Manual 36: System Restoration Revision 29 Updates

Rich Brown
Manager, System Operator Training
System Operations Subcommittee
May 10, 2021

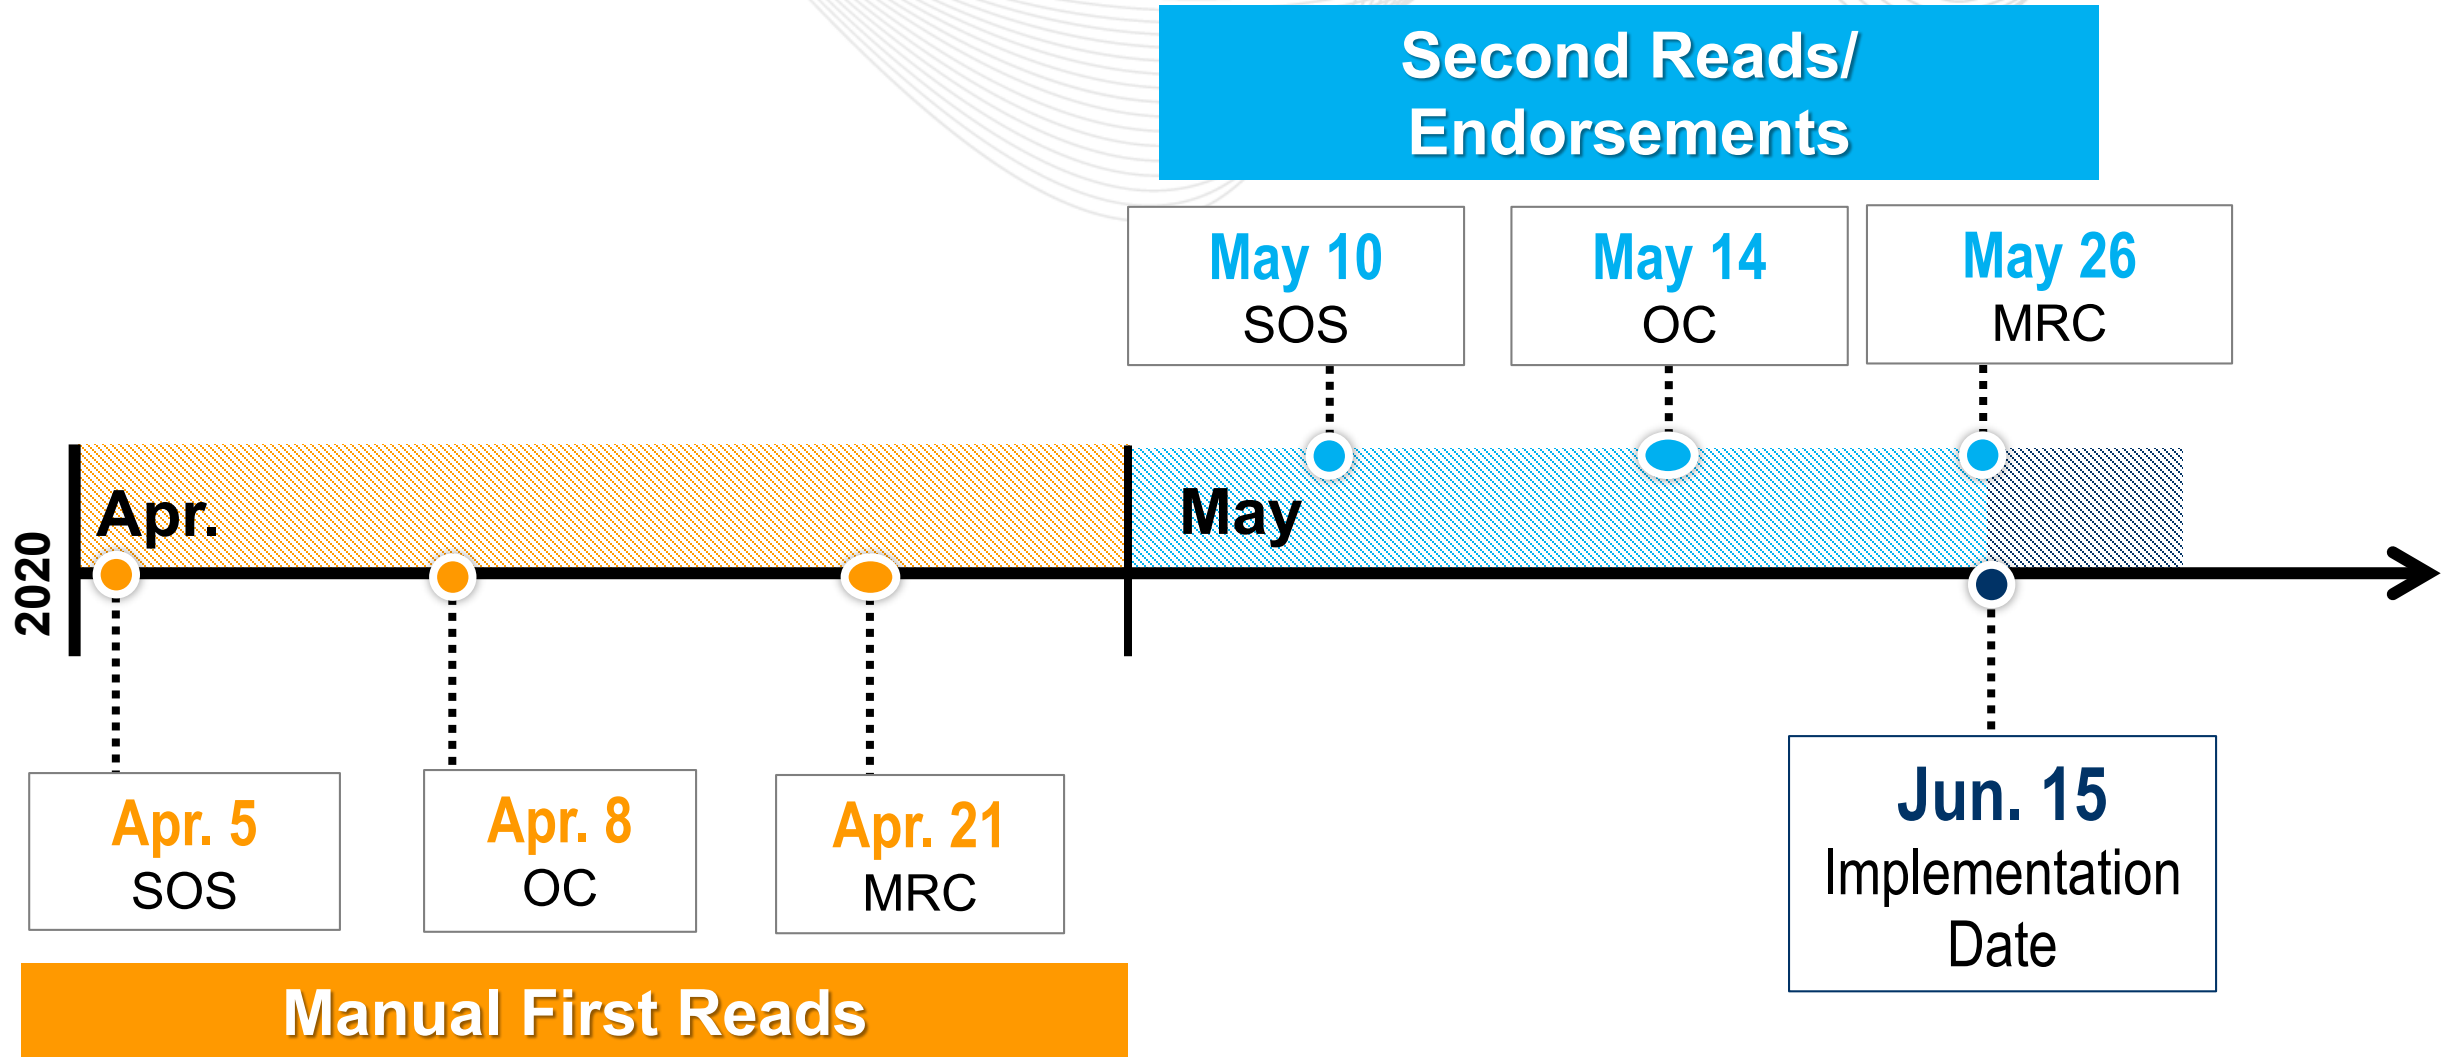
- Attachment B: Exhibit 16 replaced with a clearer image
- Attachment H:
 - Updated Under Frequency Load Shed table with new data
 - Added note: PRC-006 R10

PJM's UFLS program does not require automatic switching of Capacitor banks, Transmission Lines, or reactors. However, if a Transmission Owner uses automatic switching in order to control over-voltage as a result of underfrequency load shedding, the Transmission Owner shall inform PJM (NERC.Transmission.Planner@pjm.com), in accordance with PRC-006 R10.
